# SEATTLE PACIFIC UNIVERSITY MAJOR INSTITUTION MASTER PLAN

# SEATTLE PACIFIC UNIVERSITY REVISIONS to the PRELIMINARY DRAFT MIMP

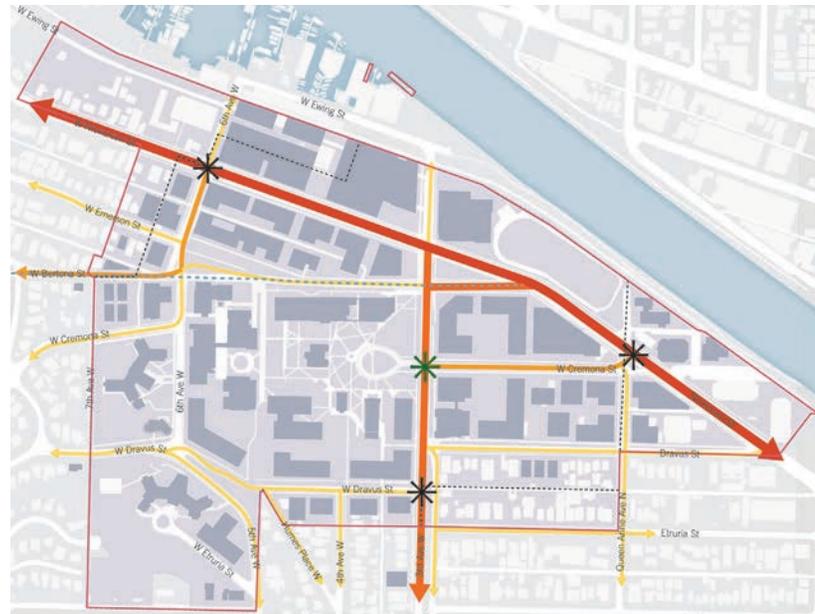
- Inconsistencies with names and numbers.
- Missing some code requirements.
- Typos.
- Requests for clarification.
- Requests for reorganization.

- Edited for clarity and consistency.
- Edited for legibility, navigation, and organization.
- Included more detailed and comprehensive information.
- Reorganized Document.
- Investigated numbers in more detail, cross-checked among sources.
- Placed maps with existing and potential conditions side-by-side and all potential maps on the right.

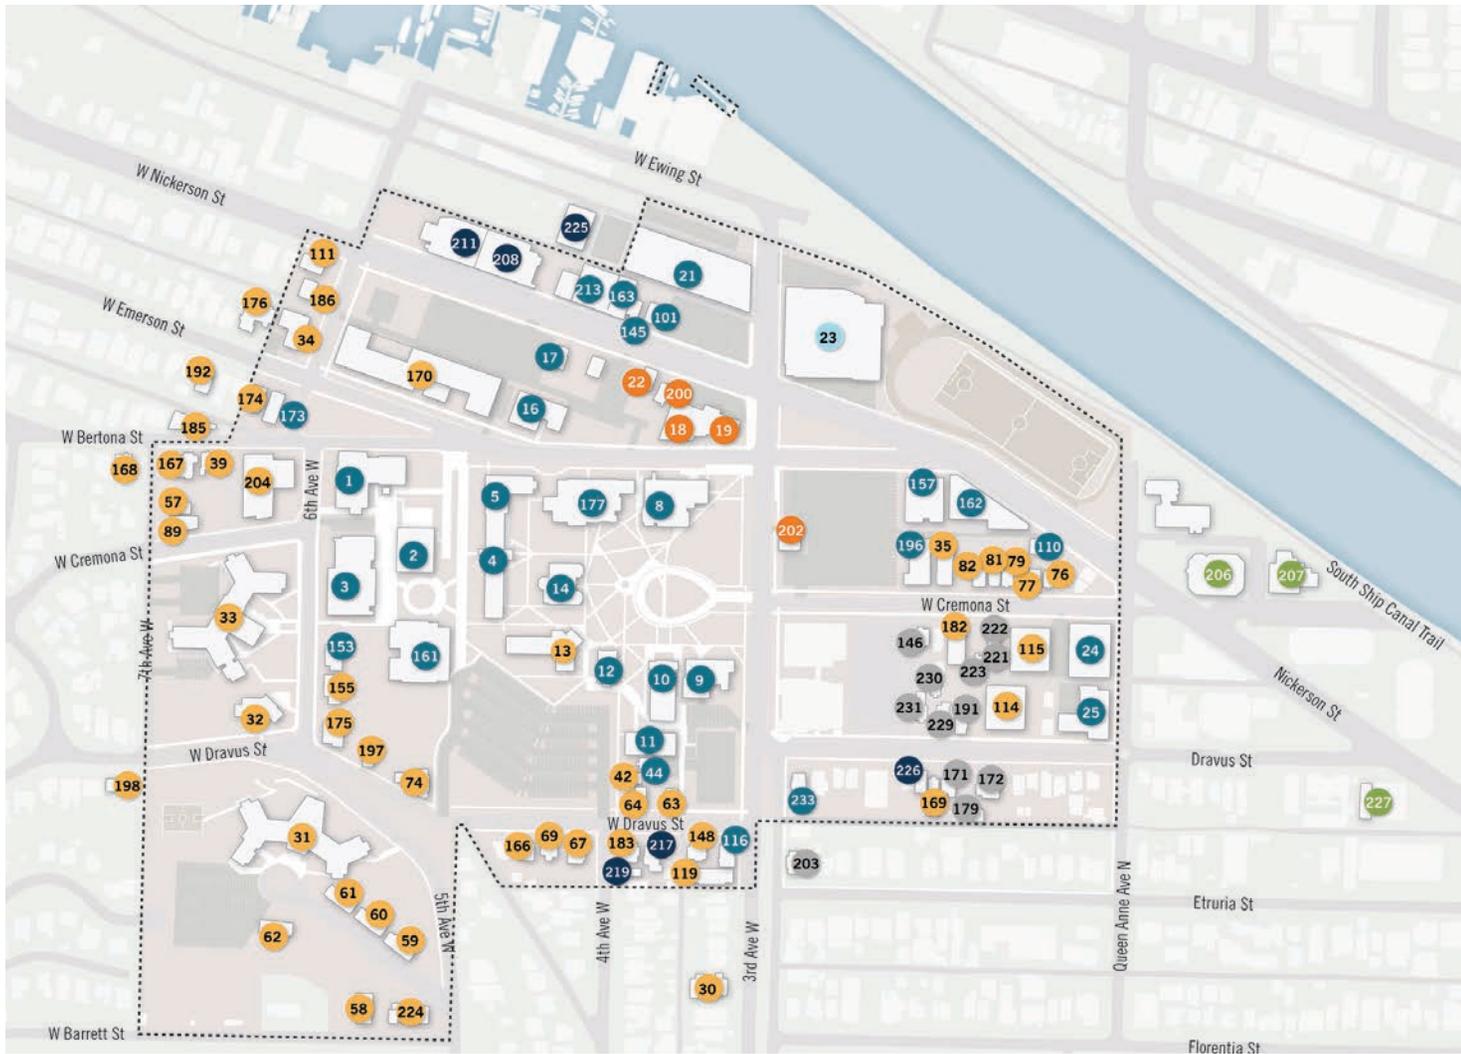
- What guidelines are in place to achieve desired character and scale?

- Added Design Guidelines to guide decision-making as projects become more defined.

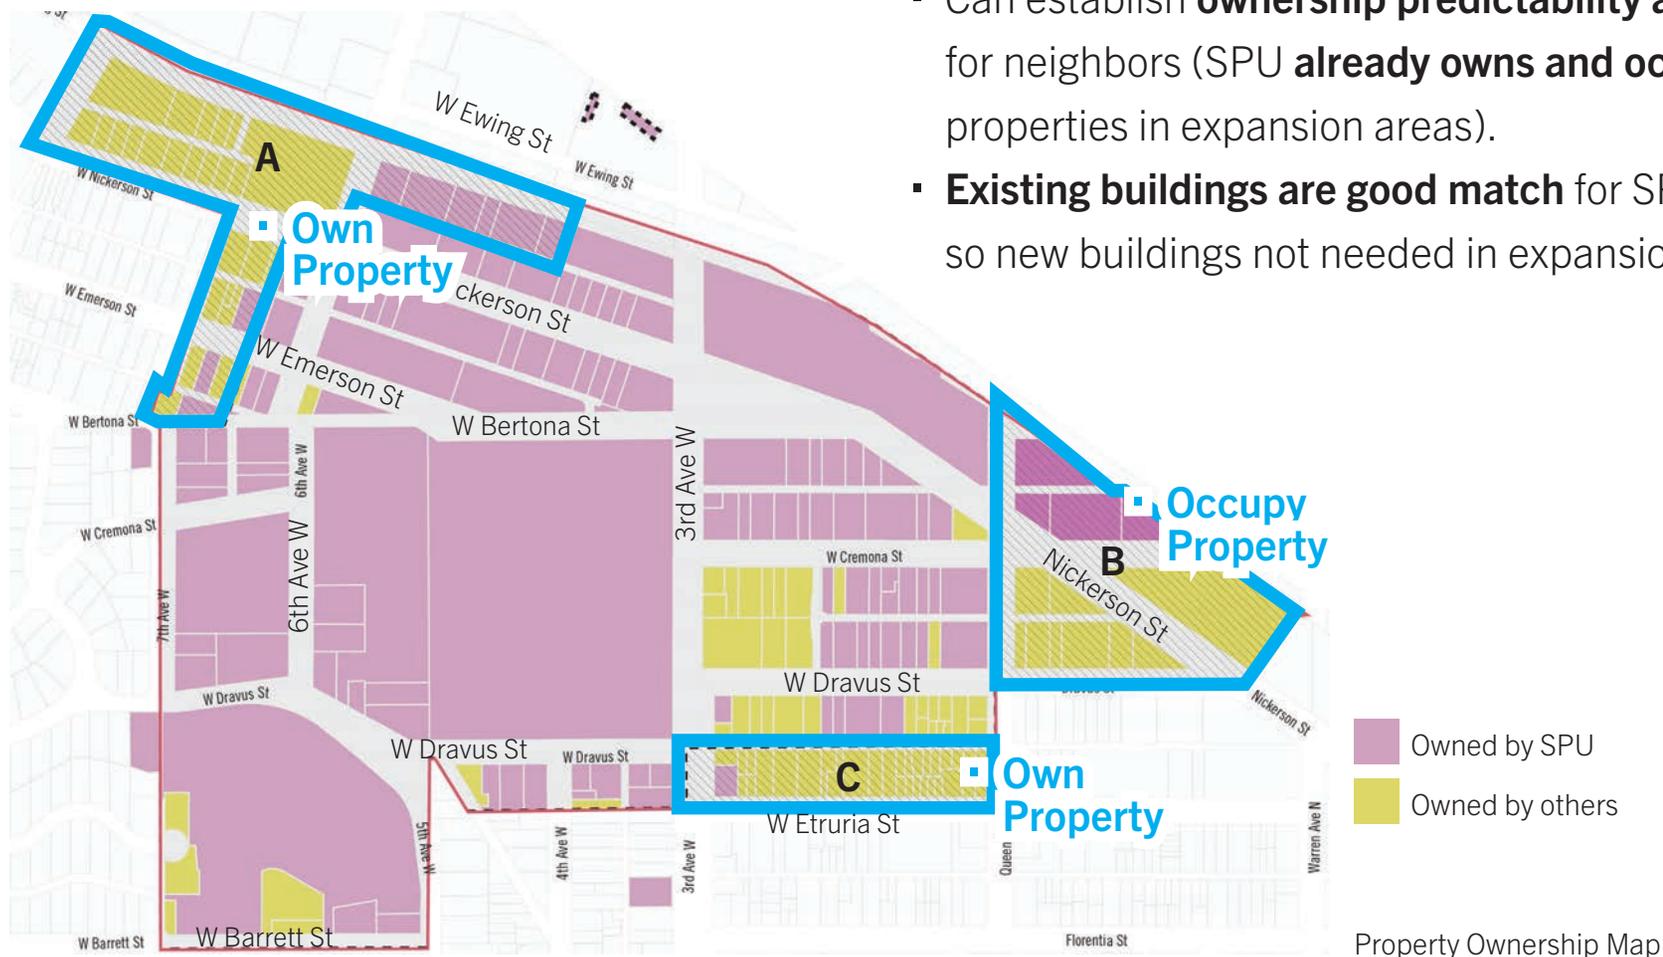
- Why does SPU want to grow?
- Why is SPU expanding when enrollment is declining?
- Why is SPU expanding during a pandemic?
- Why aren't you switching to remote learning?

- SPU needs to grow to:
  1. Support long-term enrollment growth aspirations.
  2. Match space types and sizes with current and future pedagogies.
  3. Remain competitive with other institutions in the higher education landscape.
- Anticipate an initial enrollment decline followed by steady increase.
- Pandemic reinforced the importance of on-campus, in-person education model.
- MIMP has decades-long planning horizon. Anticipate COVID-19 will not meaningfully affect the potential development program.
- Addressed all above topics in revised document.

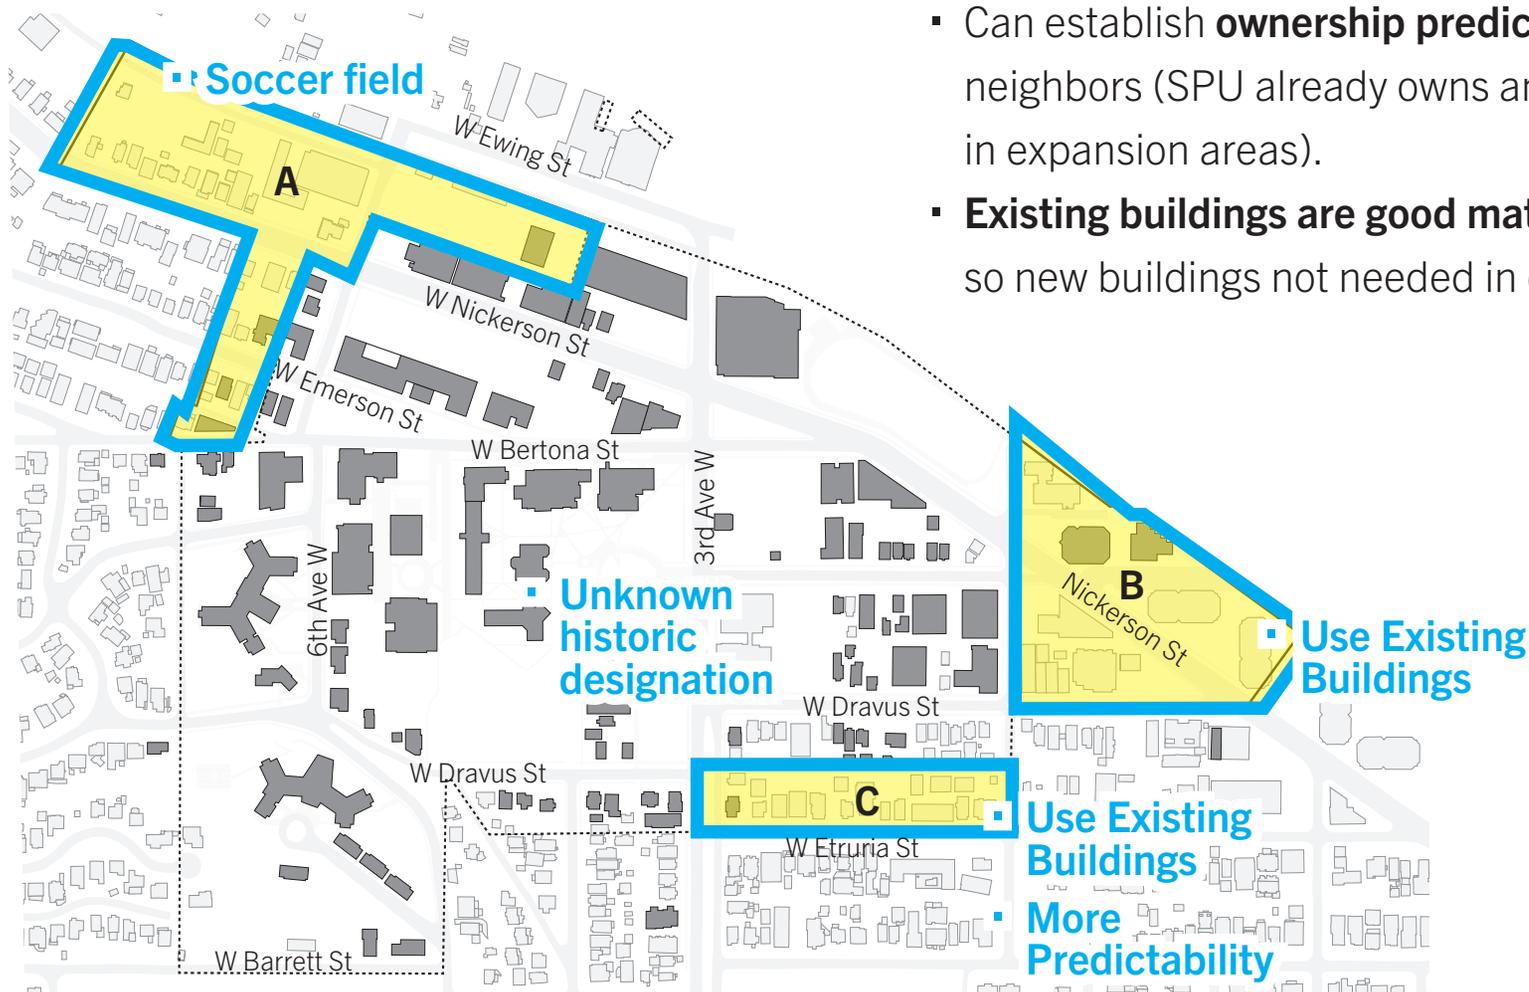
- Why is no development shown in expansion areas?

- Need to prepare for **unknown historic designation**, which could prevent reusing existing campus buildings.
- Need to provide **space for soccer field** in case City does not extend Interbay lease.
- Can establish **ownership predictability and access** for neighbors (SPU already owns and occupies properties in expansion areas).
- **Existing buildings are good match** for SPU program, so new buildings not needed in expansion areas.

Proposed Zoning Diagram

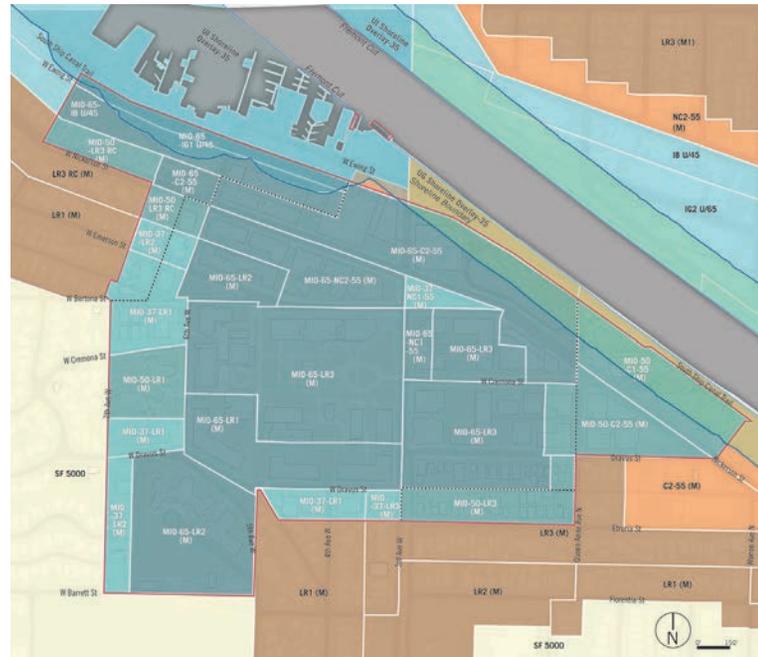
- How are proposed heights and other standards different from underlying zoning?

- Revised map includes underlying zoning and proposed MIO height designations.
- New modifications table shows difference between underlying standards and proposed modifications.

New Building Heights Map

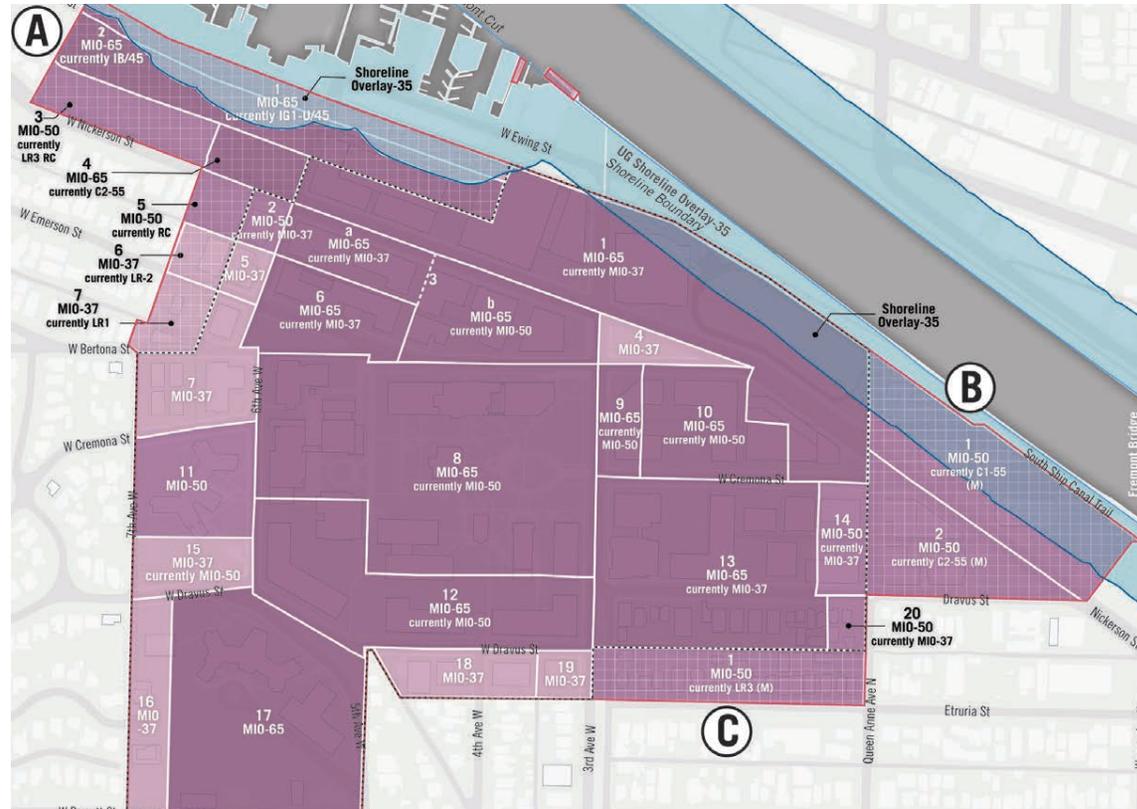
- Building height information is in several places and should be in one.

- Added new MIO height limit map and reference table.
- Consolidated height discussion.

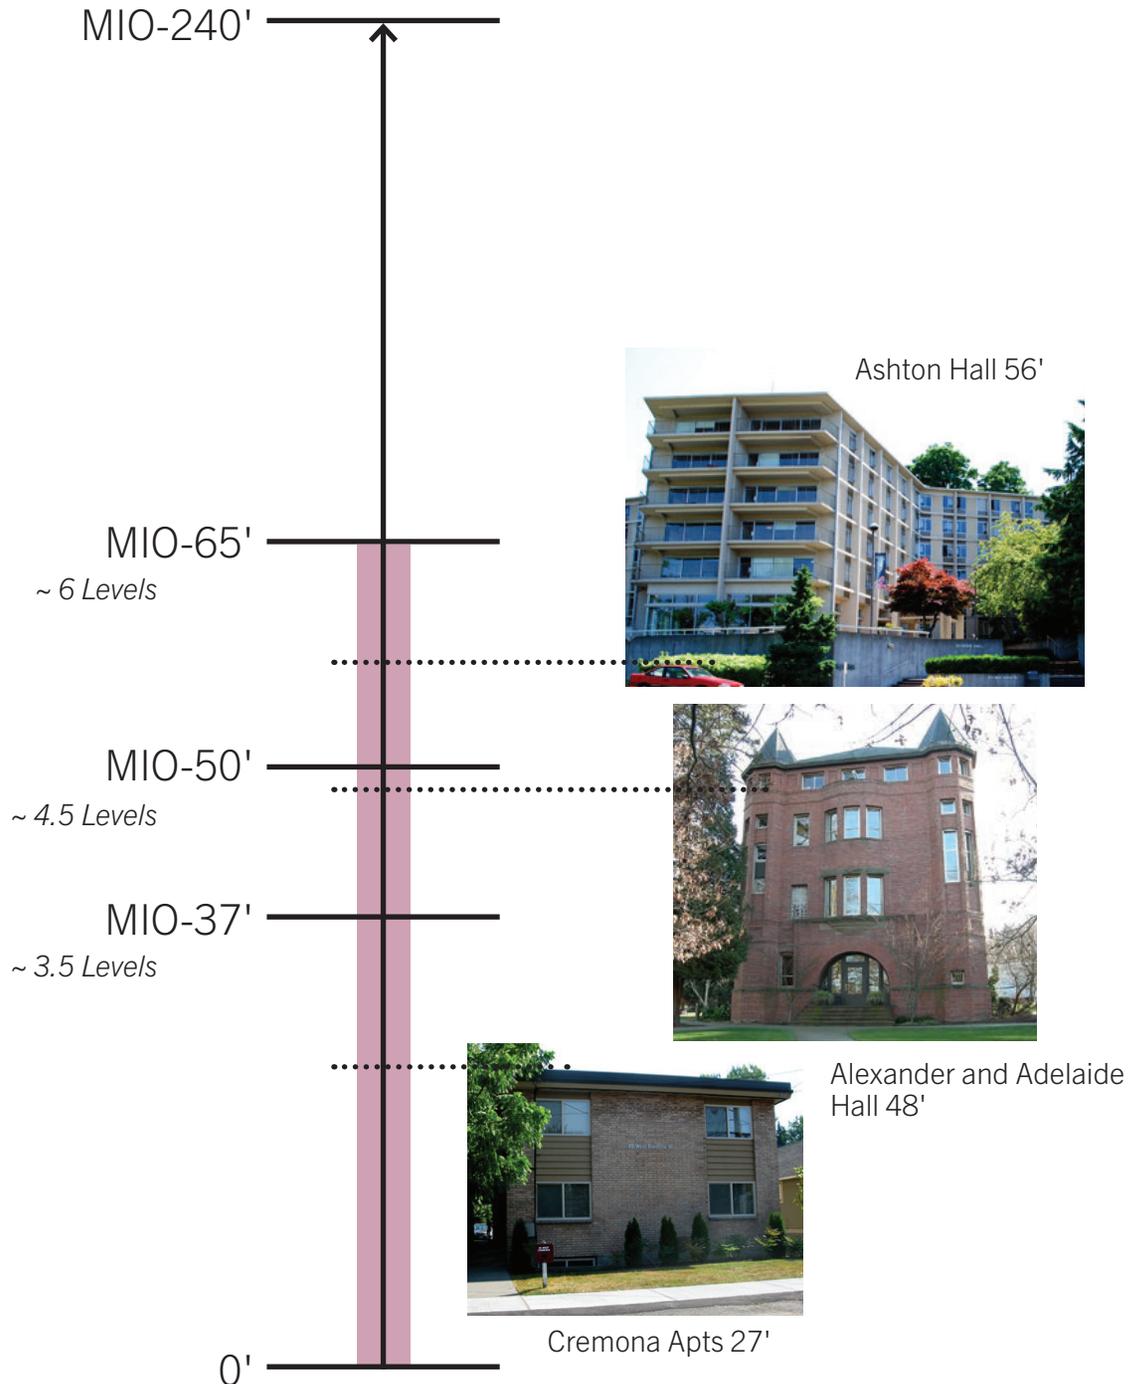
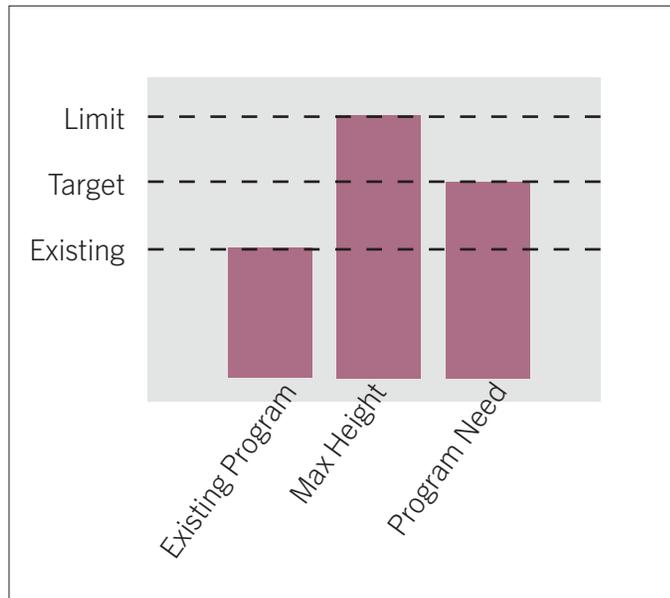
- Why don't potential building heights reach MIO height limits?

- MIO heights are increments/ranges.
- SPU proposes heights based on program need, not maximum heights.
- Different building types have different floor-to-floor heights.

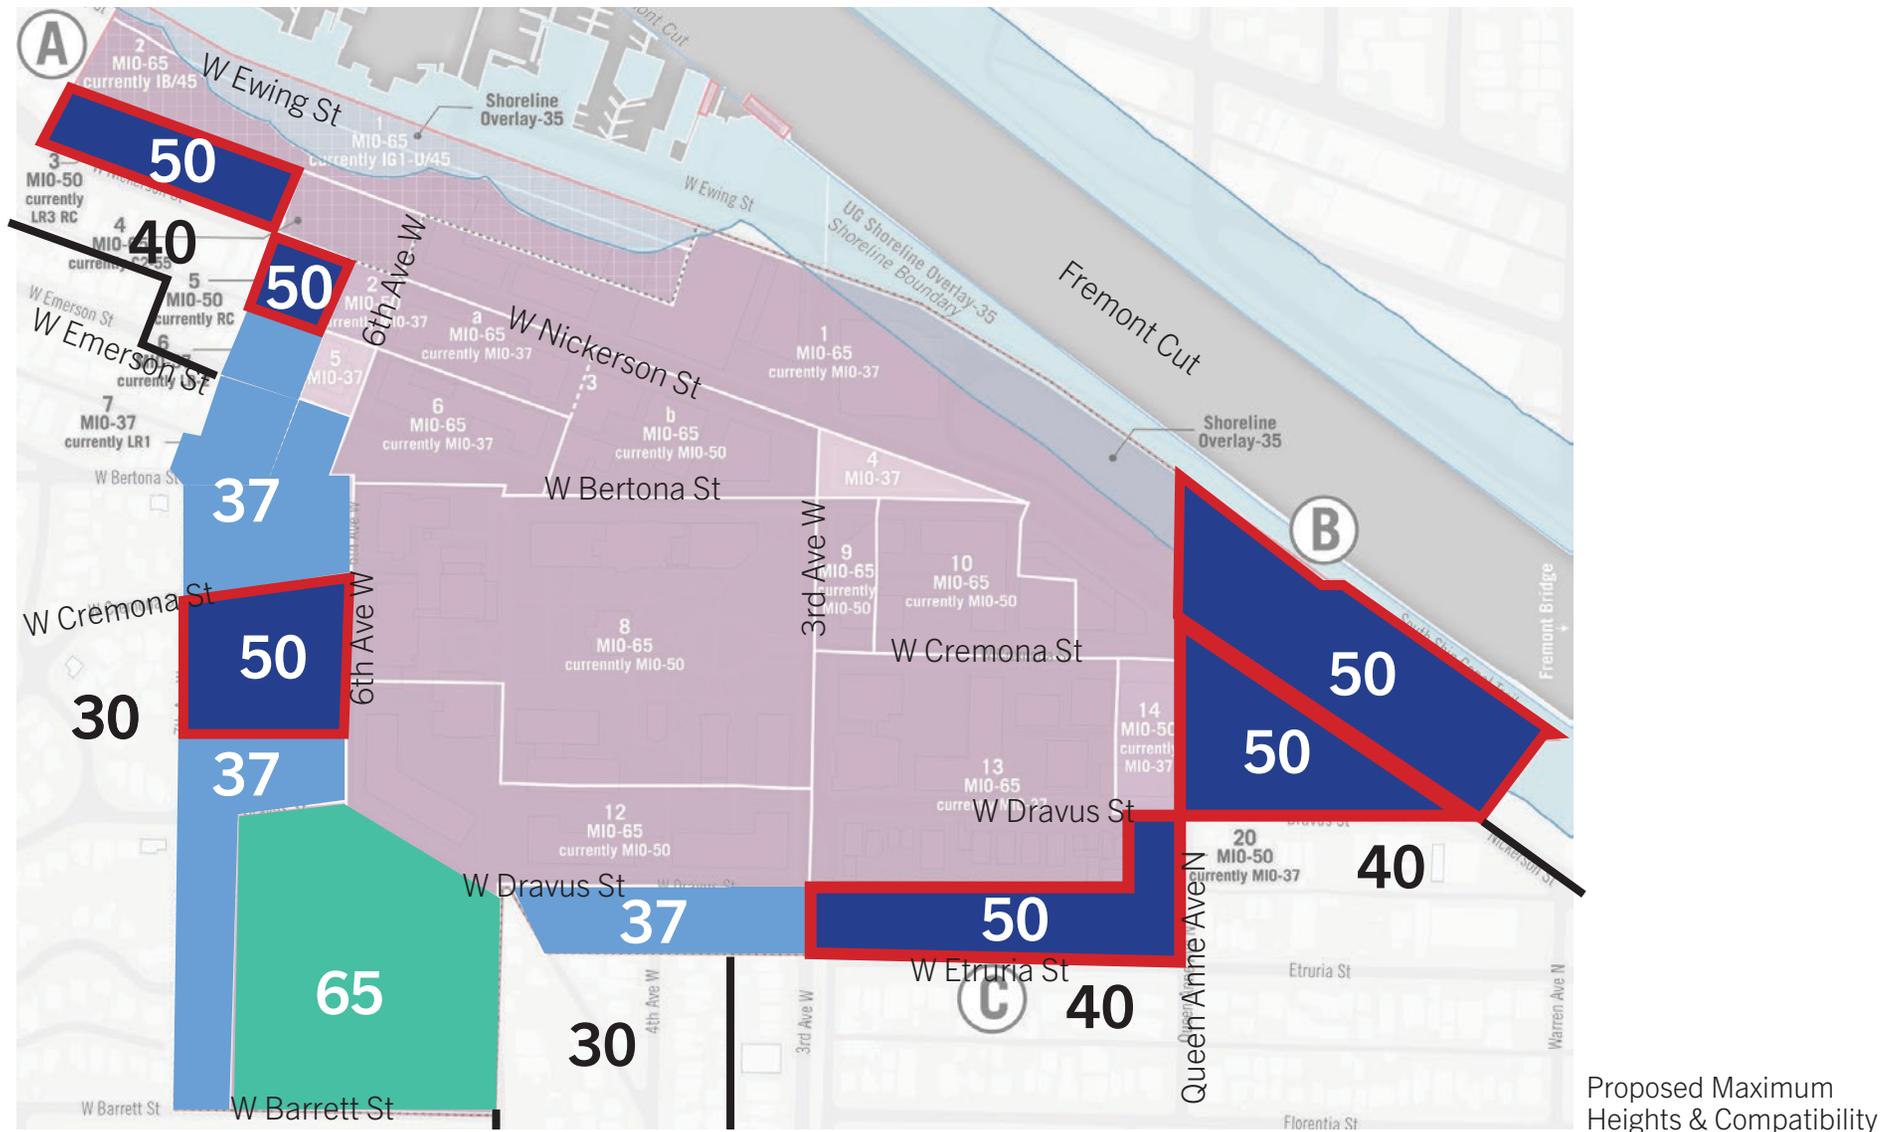
- Potential building heights in proposed MIO are not compatible with surrounding zones.

- Adjusted heights in areas adjacent to surrounding zones.
